CS Memorandum No. 1336

Subject: Configuration Management Board Meeting No. 109

CMB Meeting Minutes #109

SUBJECT: Configuration Management Board Meeting # 109 – Rev. No. 0

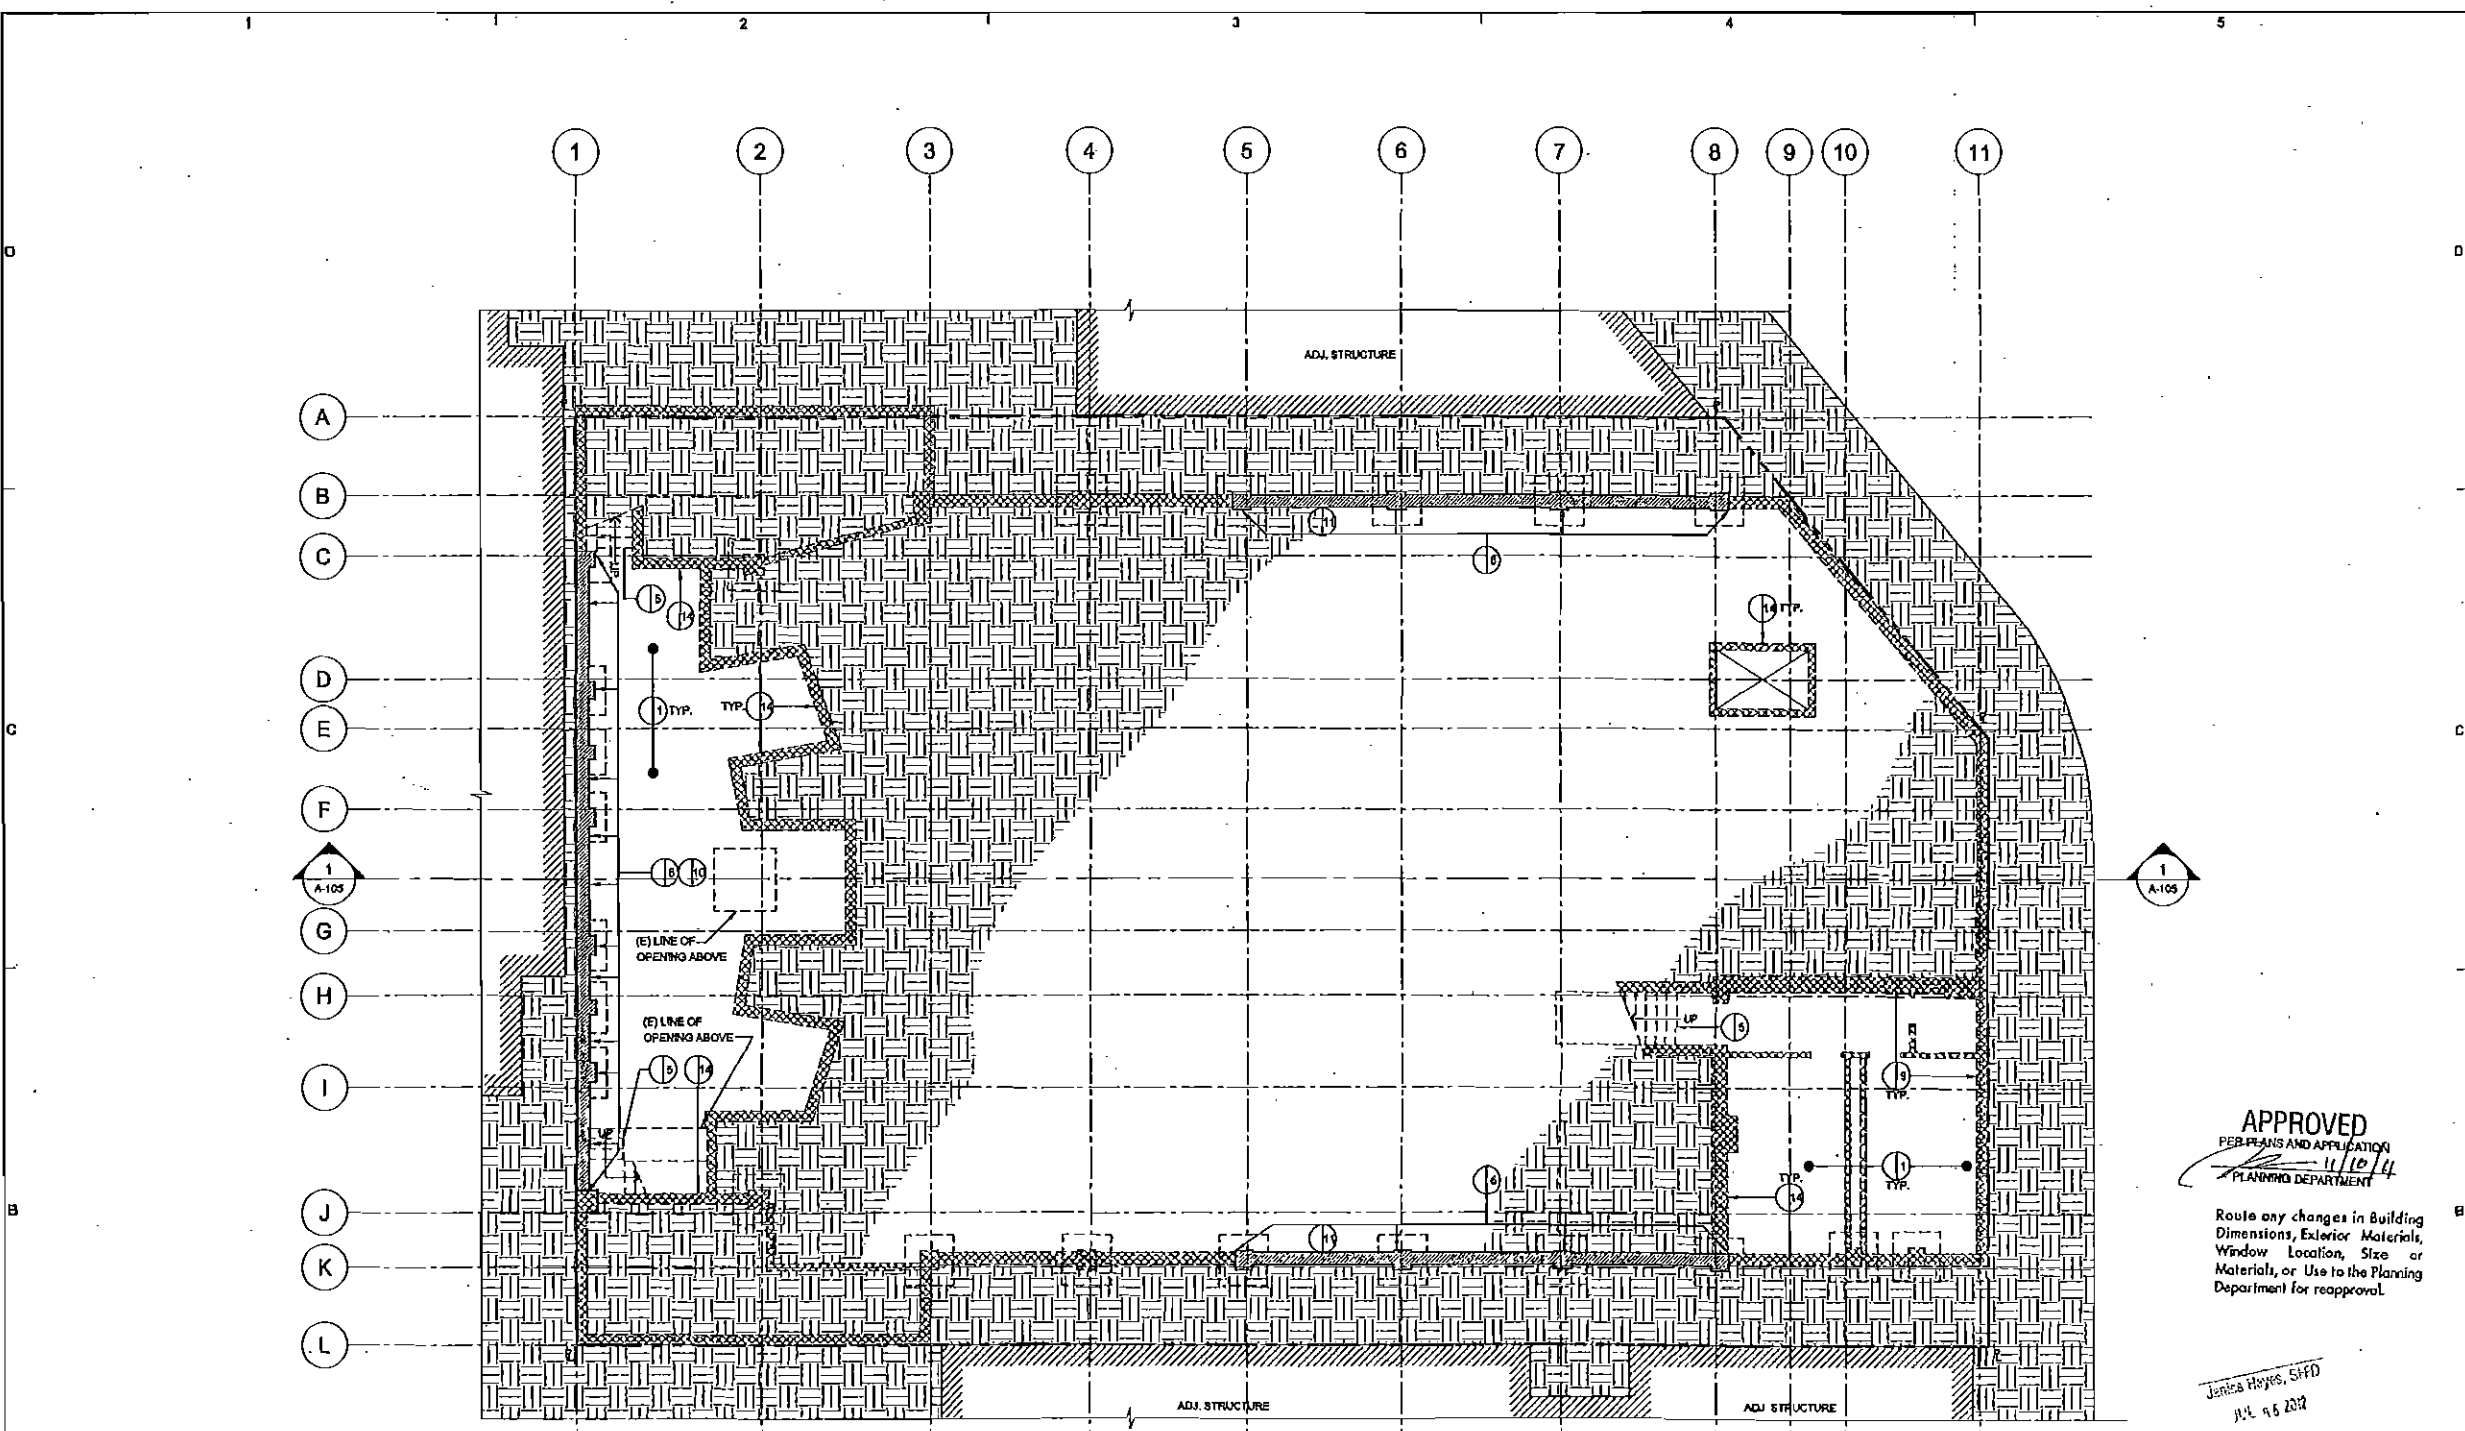
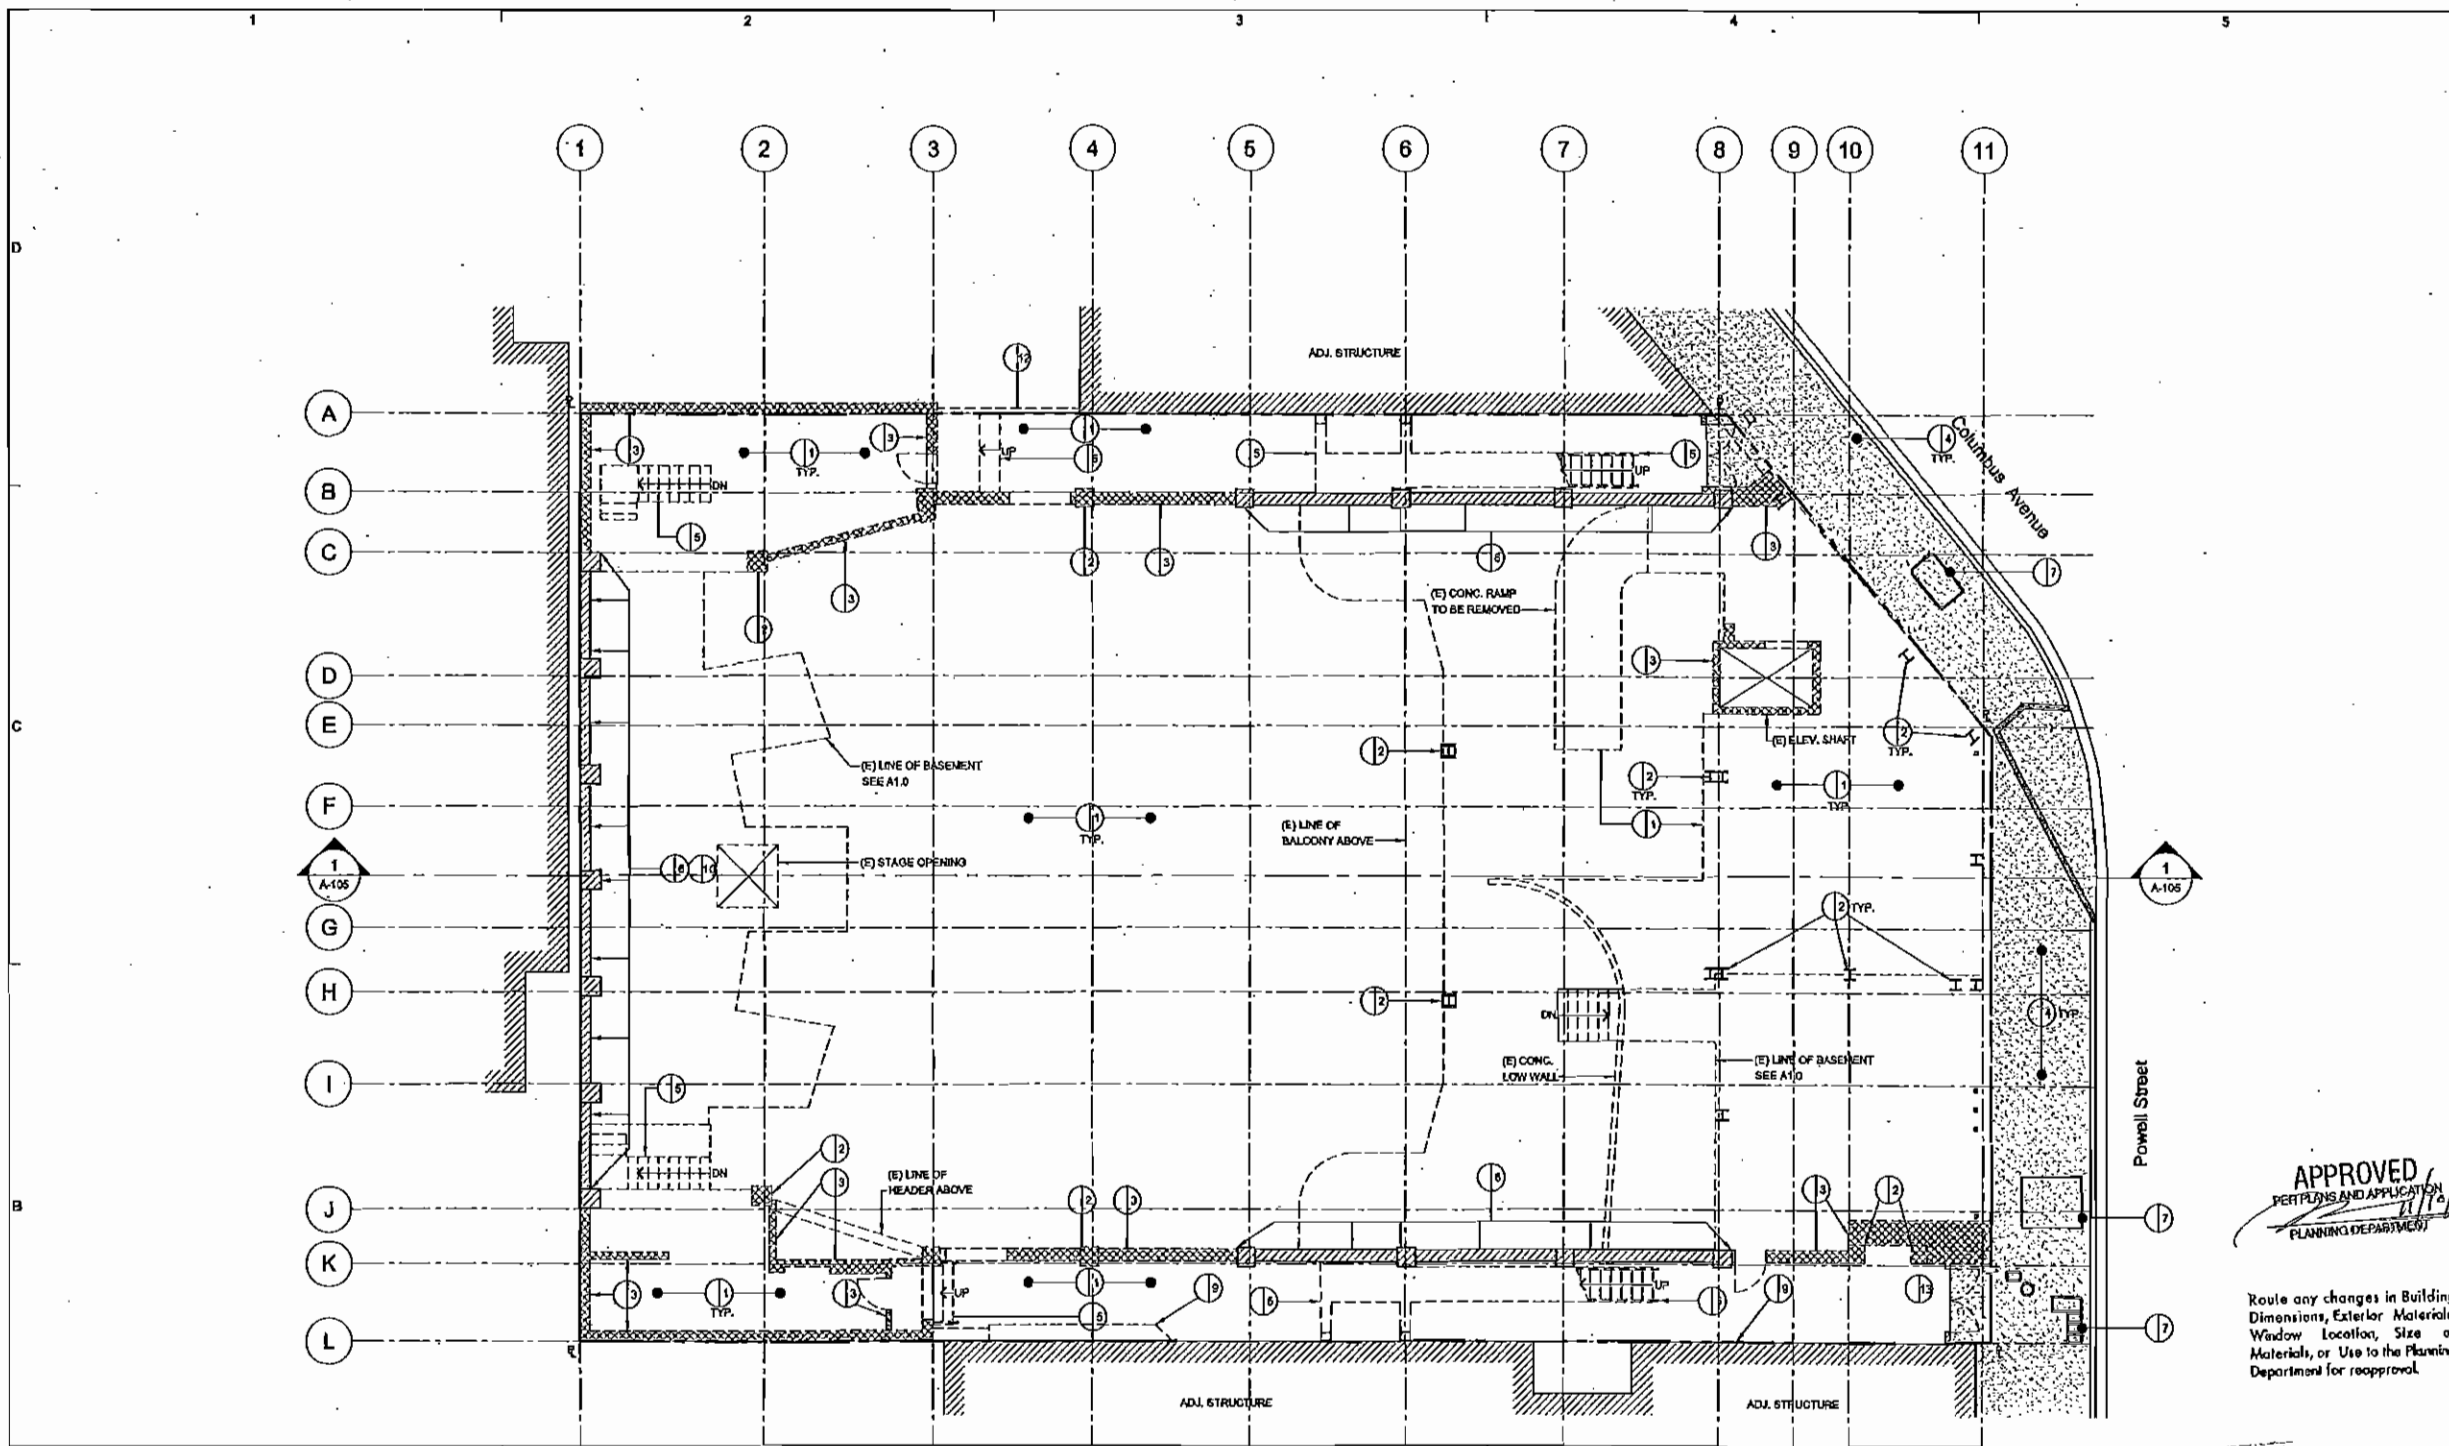
- Design and demolish existing building at 1731-1741 Powell Street. Demolition to include entire building; roof trusses and perimeter walls are not to be retained as shown in attached representative Demolition Plans.
